TOM BURSEY DESIGNS PLLC.

October 12, 2023

Re: Preliminary ADA evaluation, as well as a renovation options to provide accessibility to the volunteer fire department and to reconfigure the entrance, and upstairs access.

ADA Assessment for Cavendish Volunteer Fire Department (CVFD)

Door Hardware

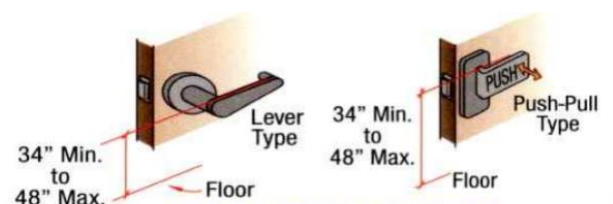
Door hardware. The door hardware on most of the doors is non-compliant.

309.4 & 404.2.7": *Operable parts (including handles, pulls, latches, locks, and other operable parts on doors and gates) shall be operable with one hand and shall not require tight grasping, pinching, or twisting of the wrist. The force required to activate operable parts shall be 5 pounds (22.2 N) maximum.*

Recommend replacing door hardware with ADA compliant hardware when major renovations are undertaken. Knobs that require a full hand grip and turning, including round door knobs, do not comply because they require twisting of the wrist. The force to open complies.

Image 4799 Floor grate in lower bay L1- is non-compliant.

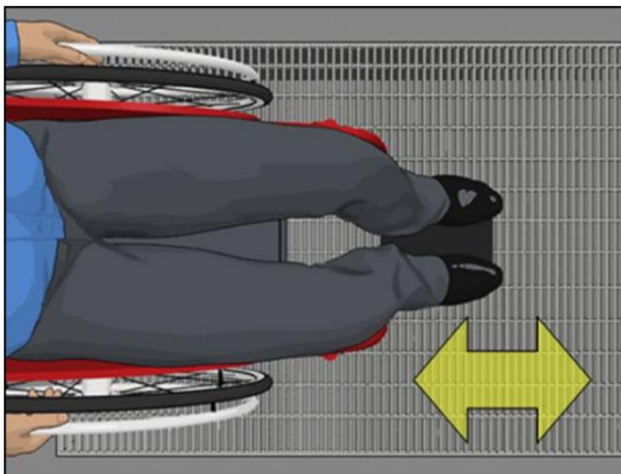
Openings in floor or ground surfaces must not allow passage of a sphere more than 1/2" diameter except as allowed. Elongated openings: perpendicular to the dominant direction of travel.

This seems like a lower priority. Accommodations shall be provided if required.
